Memorandum

To: Anne Hersch, City of Albany
From: Christy O'Berry
Reviewed by: Jonathan L. Kramer
Date: January 23, 2012
RE: PAI I-052 (Sprint/Nextel)
520 Cleveland Avenue

Figure 2: Existing Sprint coverage in the LTE 1,900 MHz band of service as asserted by Sprint. (Source: Sprint/Nextel).

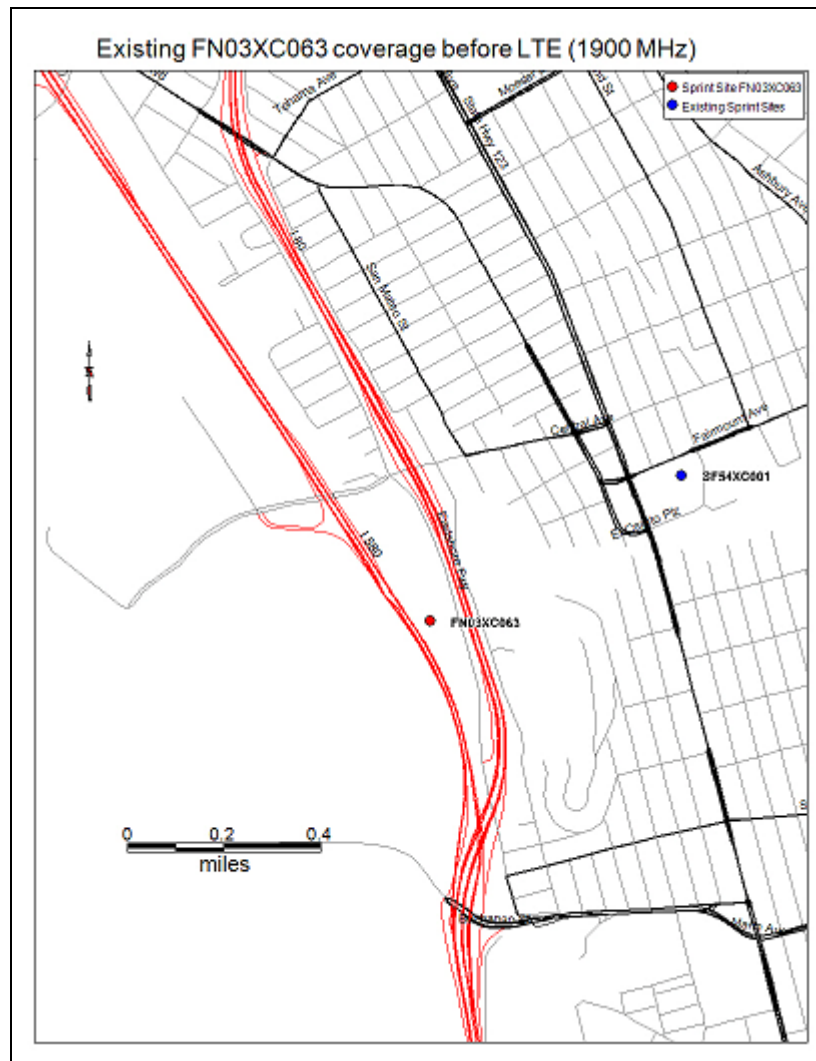
The coverage maps provided by Sprint do not contain objective signal level data for the LTE band of service in the 1,600 and 1,900MHz bands, thus the maps are not reliable as to that element, but they do suggest, but do not confirm that there is a lack of service in the LTE band of service in the 1,600 and 1,900 bands in the area surrounding the site.

Figure 3: Proposed Sprint coverage in the LTE 1,600 MHz band of service with the proposed site operational, as asserted by Sprint. (Source: Sprint/Nextel).

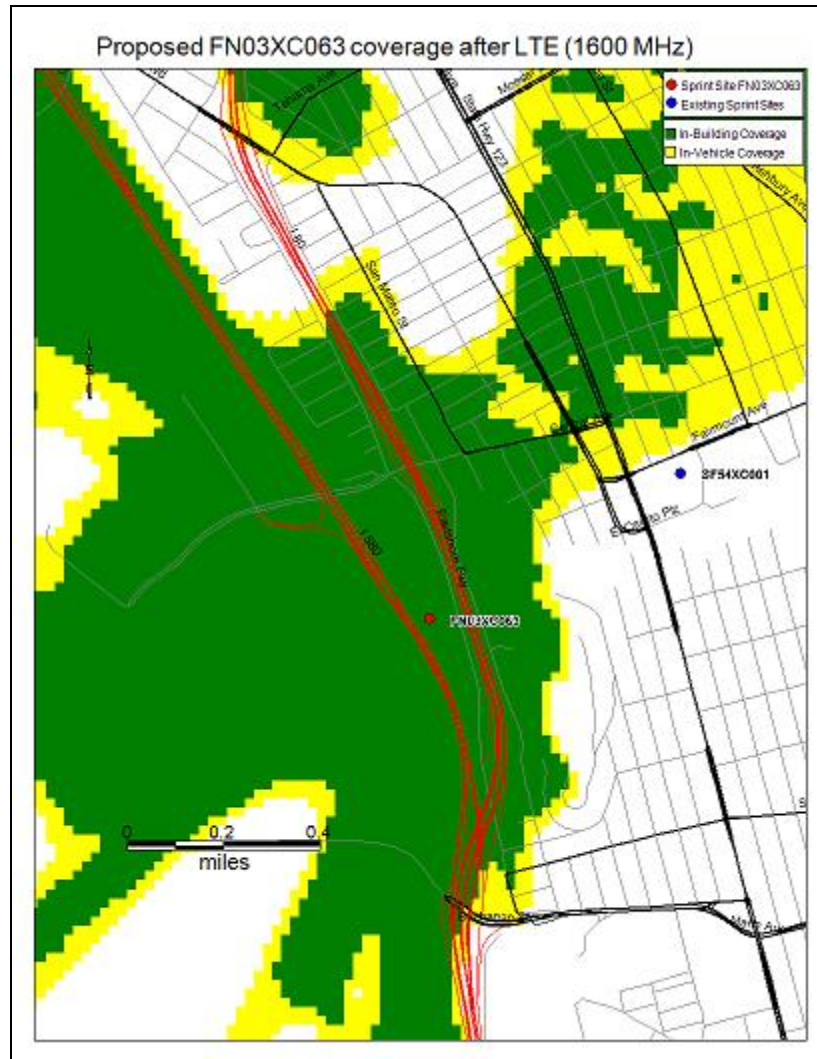
Figures 3 and 4 indicate that the proposed site will provide “in-building” signal coverage (as Sprint defines that term) to the area surrounding the proposed site.

Sprint has not provided any objective signal data for the coverage maps nor has Sprint provided the measurement used to define “in-building” service in units of dBm. Therefore, I am not able to comment on the level of signal coverage provided by the proposed site.

I recommend that the City, as a condition of permit approval, require that Sprint disclose the signal coverage levels in units of dBm that are represented in the proposed and existing coverage maps.
